Re: Transmittal of Revised Work Plan Materials
Mitigation Order on Consent, Docket No: P-500-06

**WORK PLAN TO CHARACTERIZE AND MITIGATE SULFATE
WITH RESPECT TO DRINKING WATER SUPPLIES IN
THE VICINITY OF THE PHELPS DODGE SIERRITA
TAILING IMPOUNDMENT,
PIMA COUNTY, ARIZONA**

**Re: Work Plan Addendum and Phelps Dodge Sierrita, Inc. Response
 to ADEQ Work Plan Comments Mitigation Order on Consent, Docket No: P-500-06**

GENERALIZED WELL CONSTRUCTION DIAGRAM FOR WELLS WITH SINGLE SCREENED INTERVALS

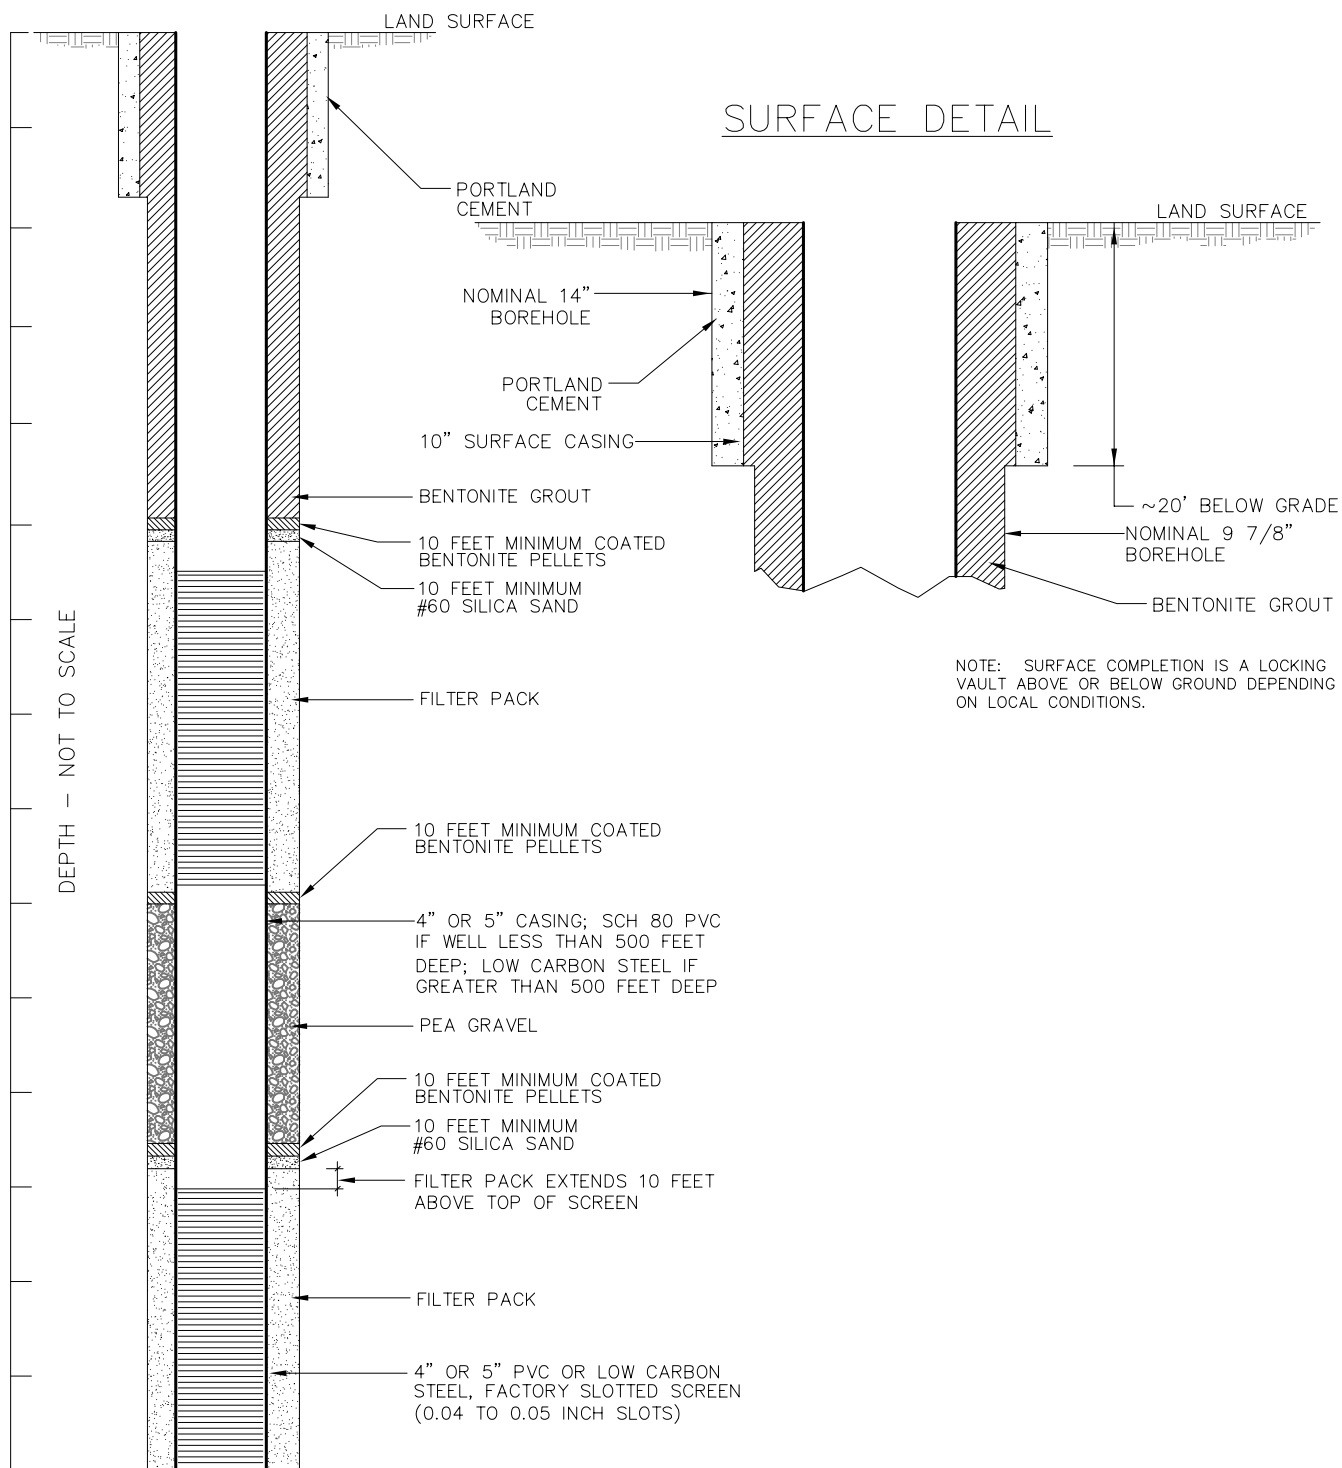
In the October 11, 2006 meeting, ADEQ identified three items as gaps in the QAPP: a list of wells to be sampled for the groundwater monitoring program (Task 2.2), a well construction diagram, and a response to ADEQ's comments regarding data review, verification and validation. These issues are addressed below to complete the QAPP.

The Work Plan and QAPP describe only general well construction methods and strategies because exact materials will be finalized based on discussion with drilling contractors, and the specifics of well depth and screened intervals will be determined in the field by the site geologist based on geologic and water quality conditions encountered during drilling. Figures 2 and 3 provide generic well construction diagrams for the two types of monitoring well constructions, single screen completions and dual screen completions, described in the Work Plan.

**WELL LOCATIONS FOR GROUNDWATER
MONITORING (TASK 2.2)**

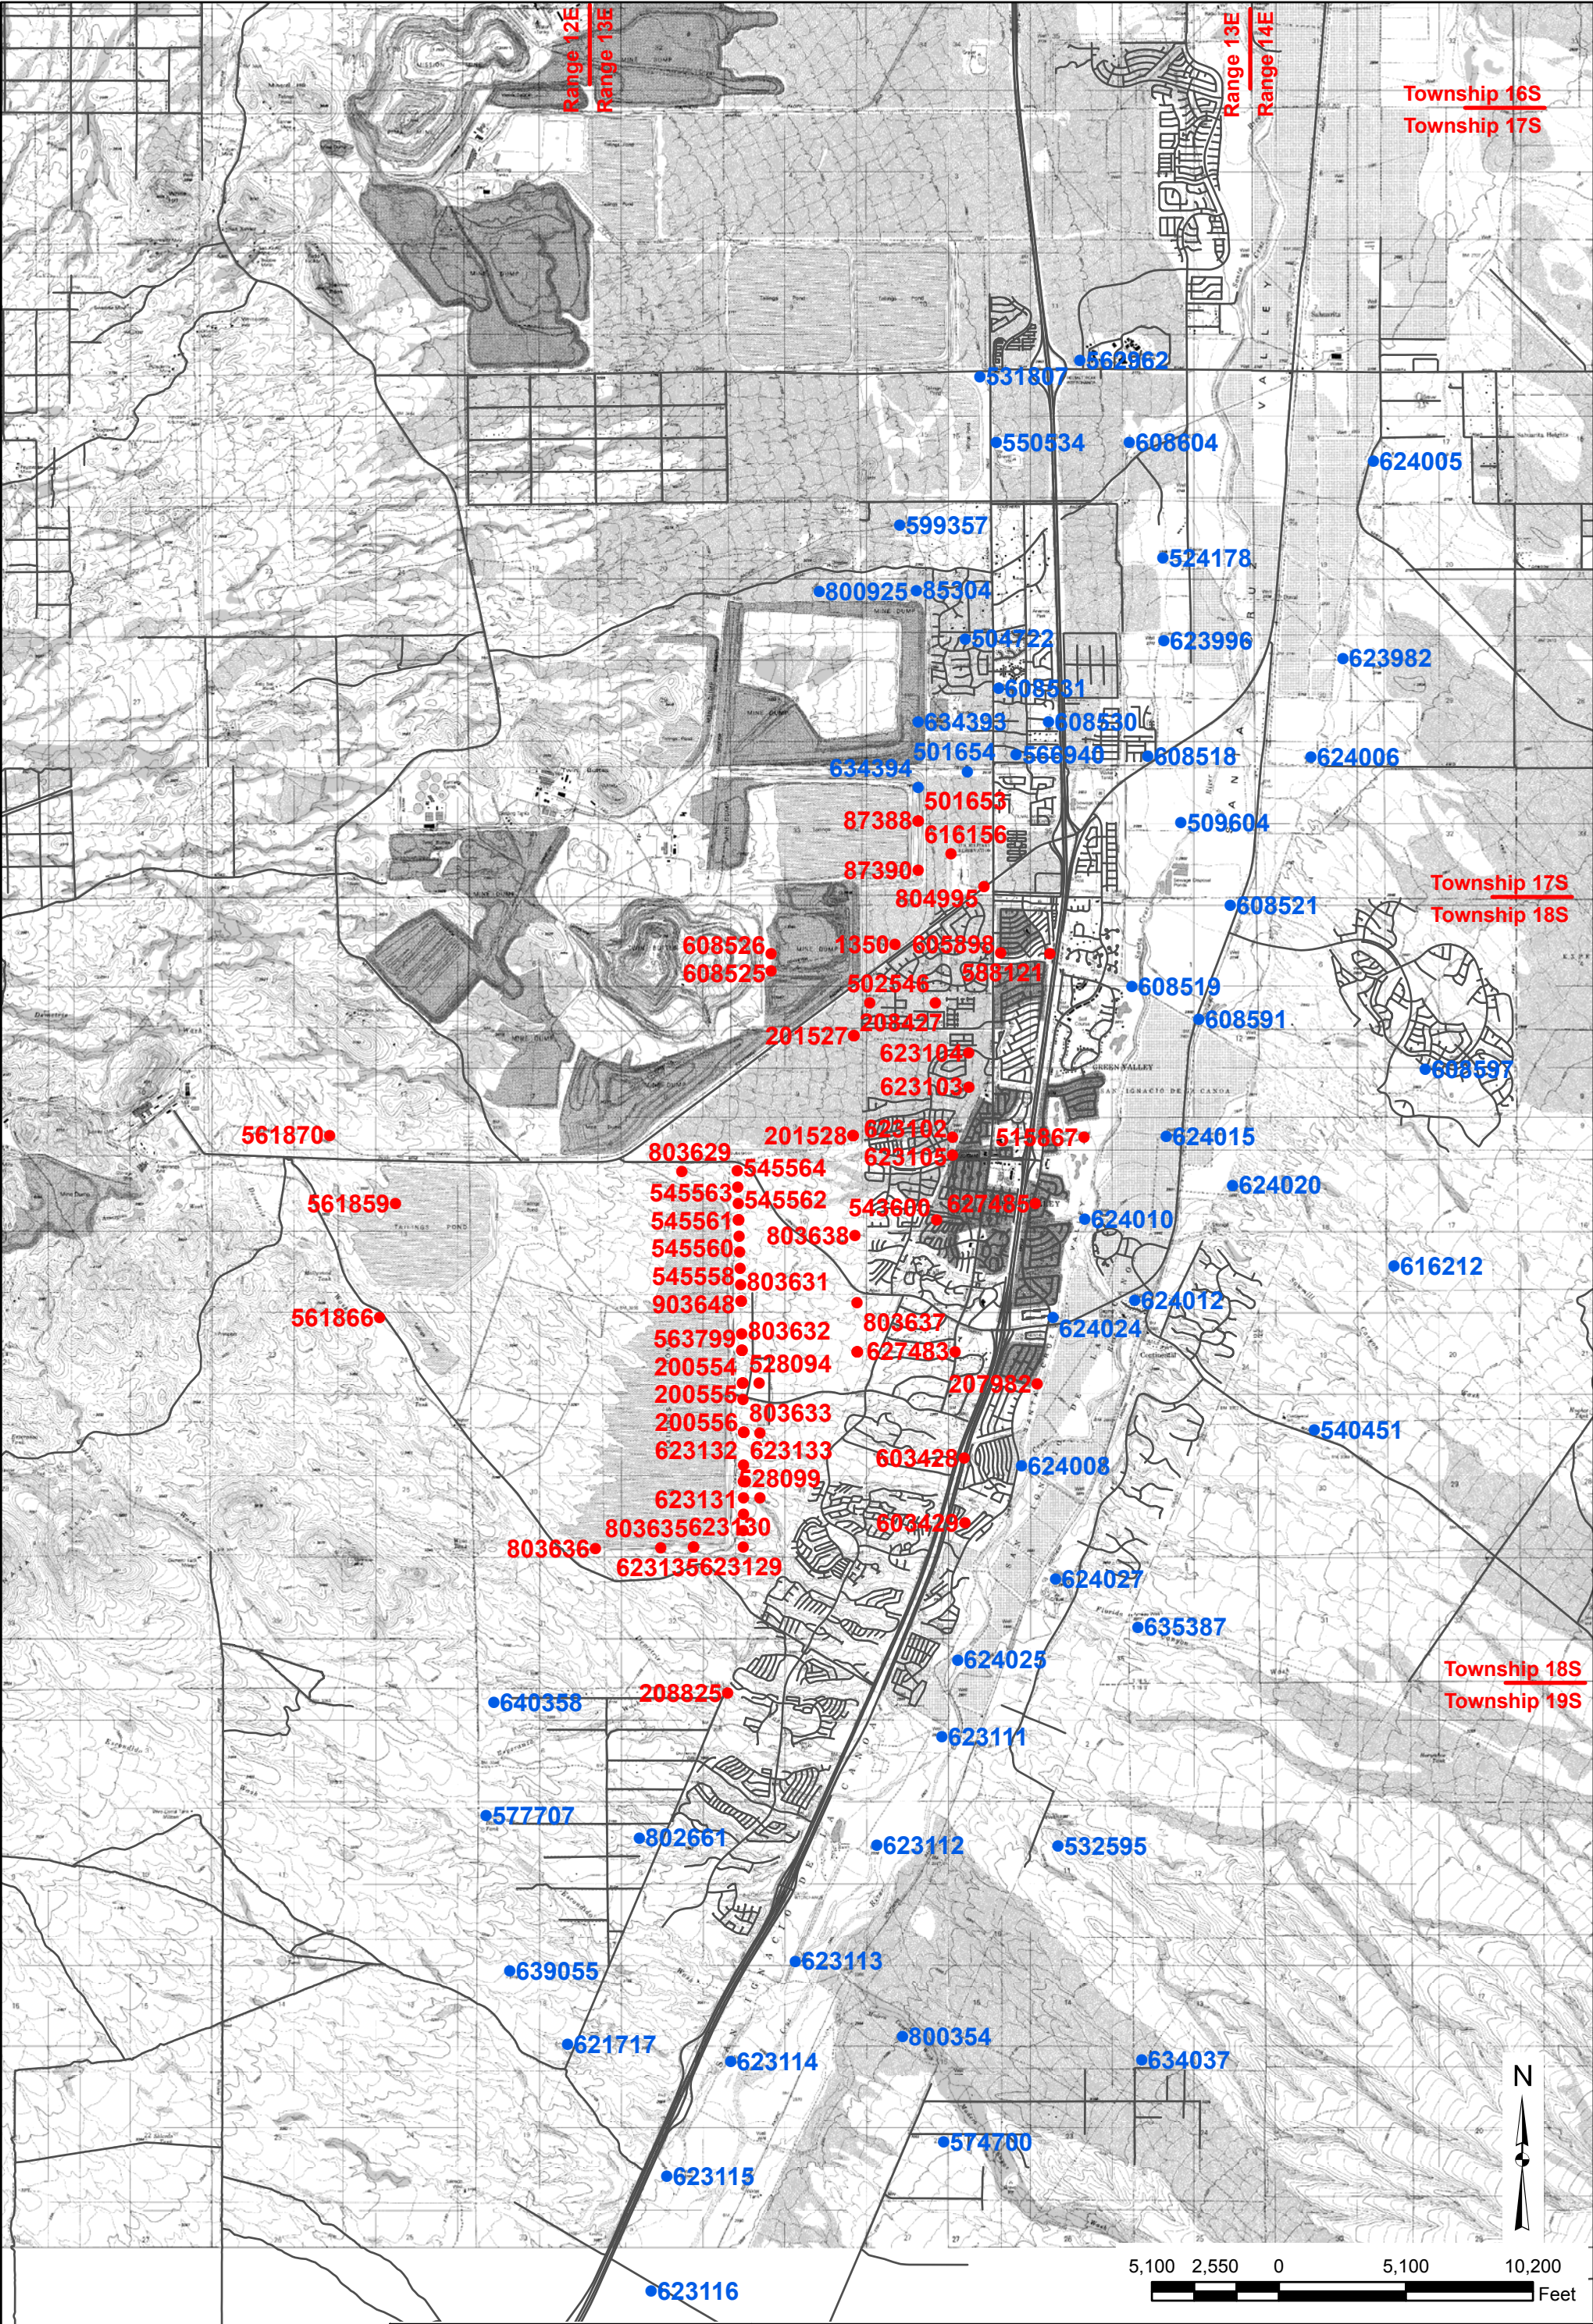
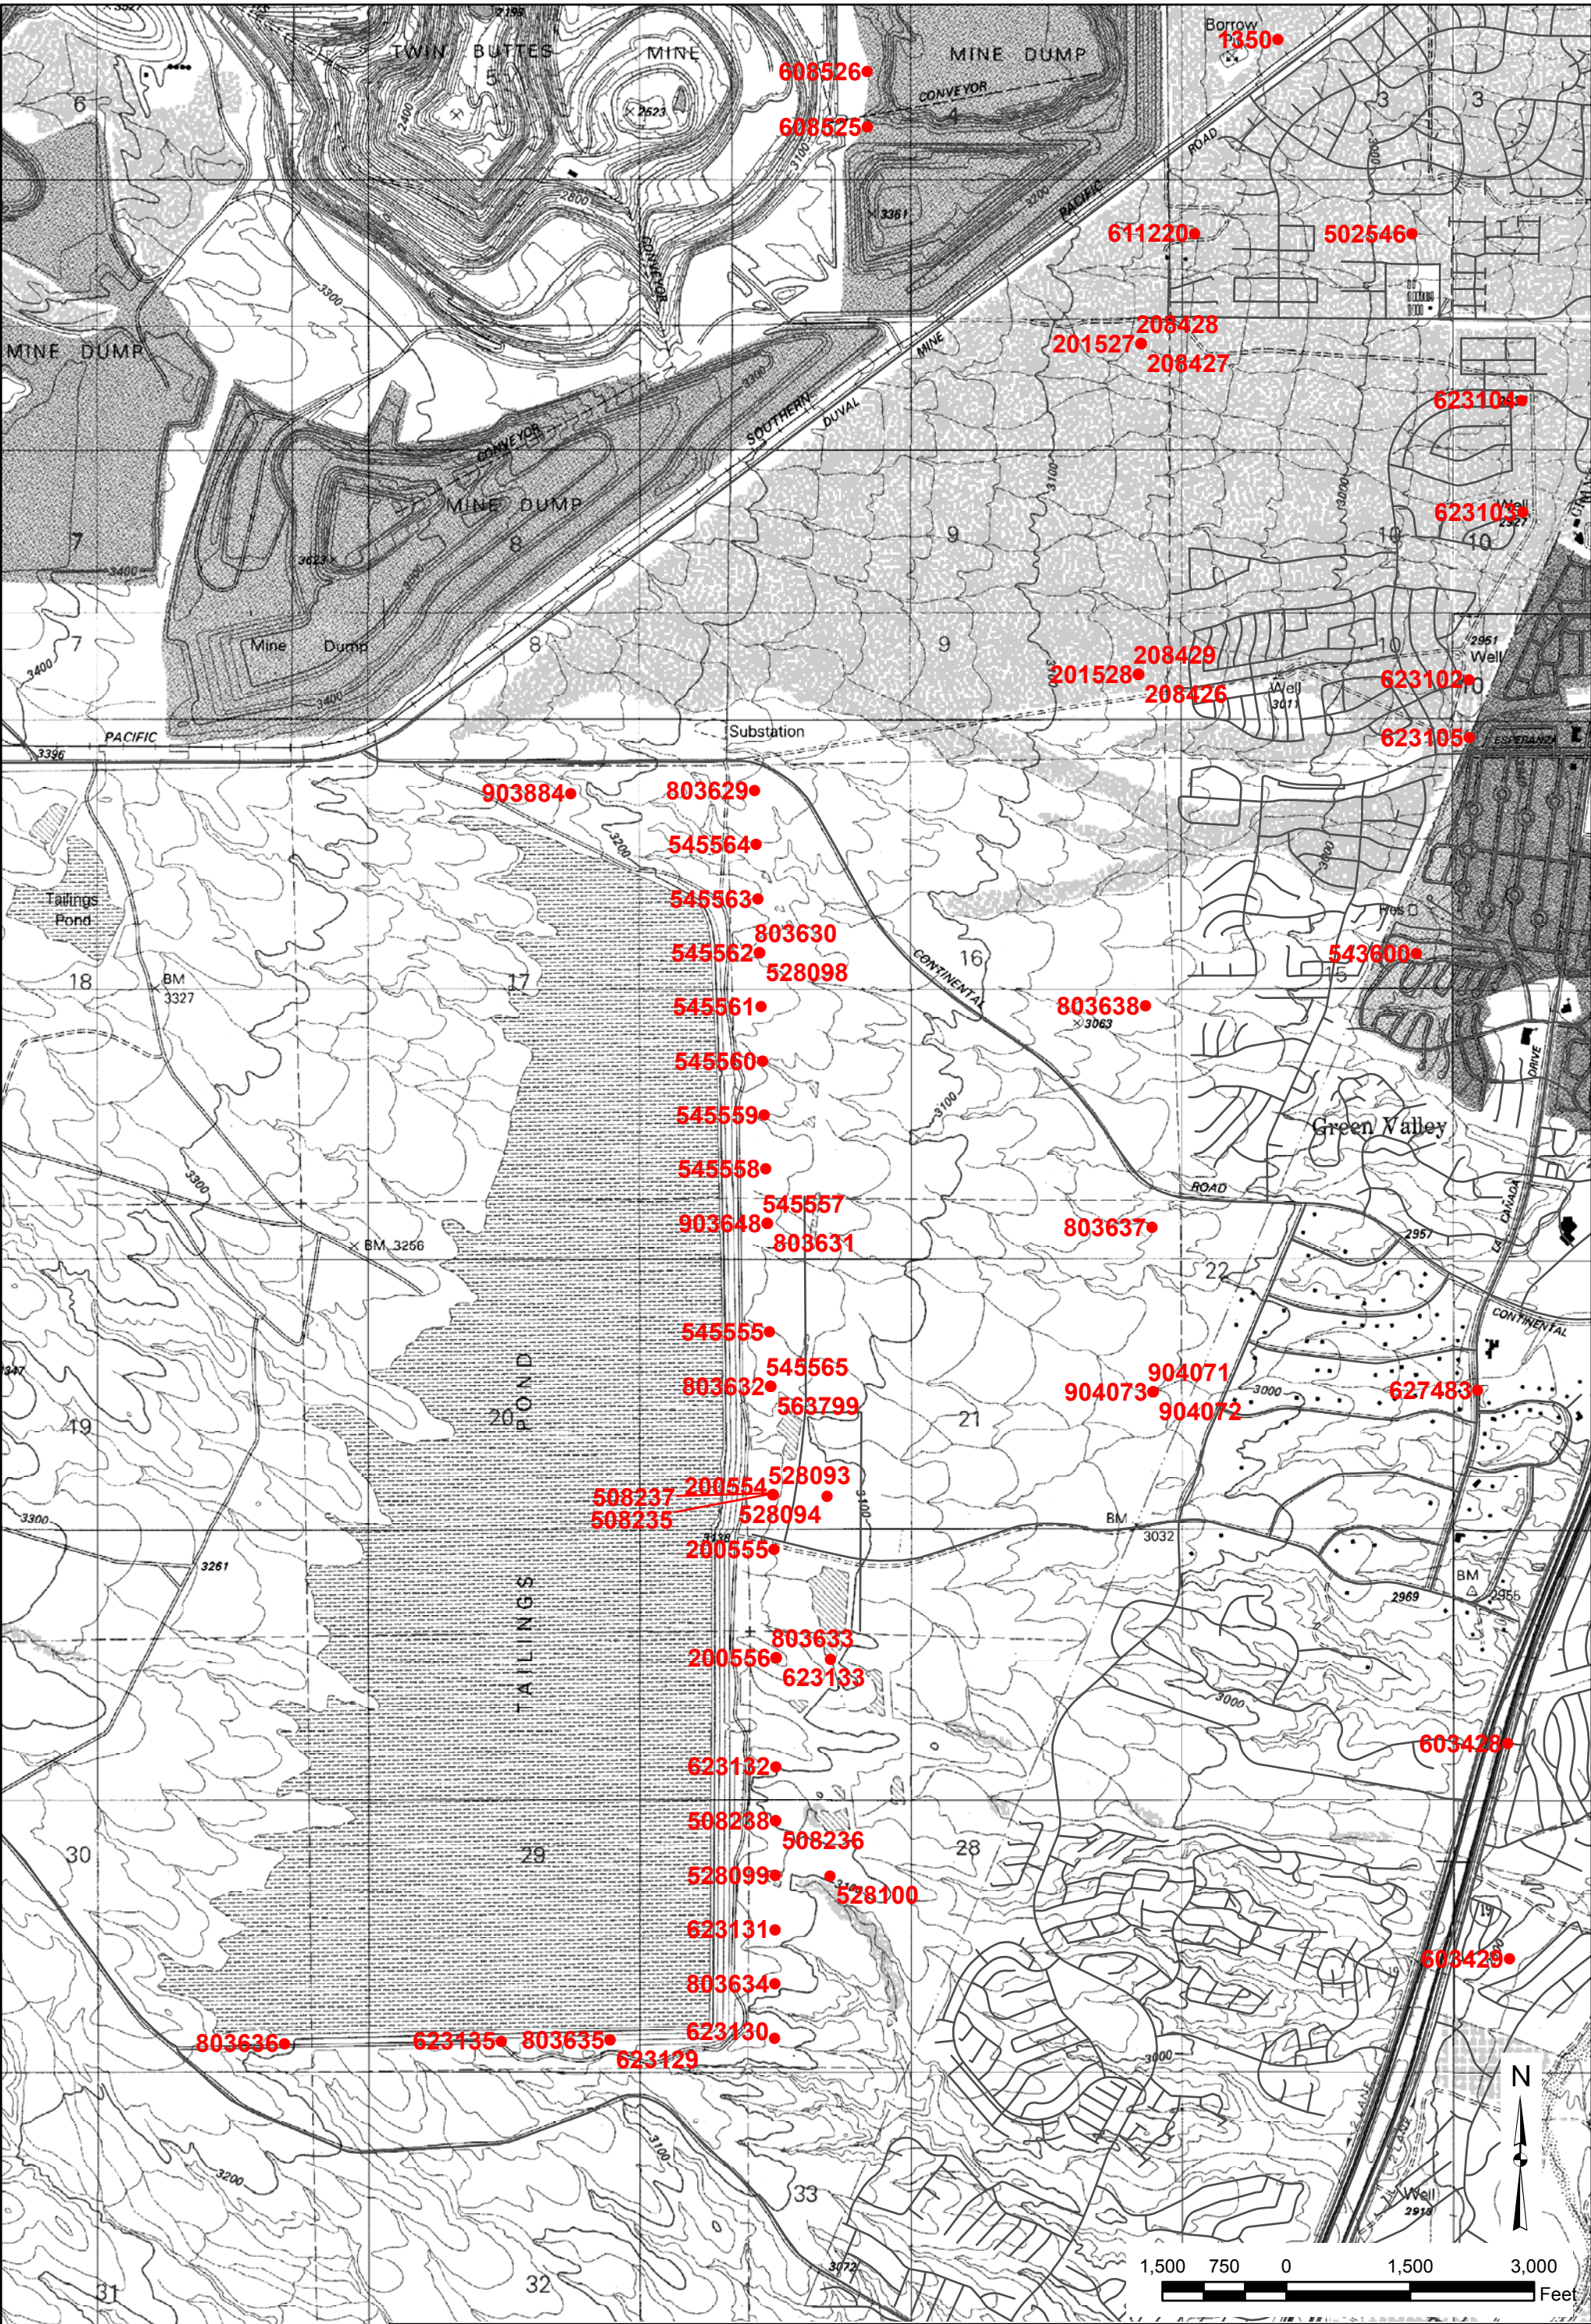
Specific sampling locations for groundwater monitoring for Work Plan Task 2.2 cannot be determined at the Work Plan preparation phase due to uncertainties regarding our ability to access or gain data from private properties, and uncertainty in accessibility of individual wells for the purpose of water level measurement (i.e., does the well possess a sounding tube for measuring water levels?). Property access, data availability, and well construction specifics will be determined during the preliminary course of Task 2.2. At the October 11, 2006 meeting ADEQ agreed:

Attachment C is a list of wells and sampling frequencies for groundwater monitoring (Work Plan Task 2.2) pursuant to the Mitigation Order. This list contains wells that PDSI will attempt to access for sampling. Wells were selected to provide geographic coverage for collection of water level and water quality data for determination of regional Potentiometric conditions and background water quality. Should a well owner refuse access or should the well be inappropriate for sampling based on construction or other considerations, a nearby alternative well will be accessed if one is available.
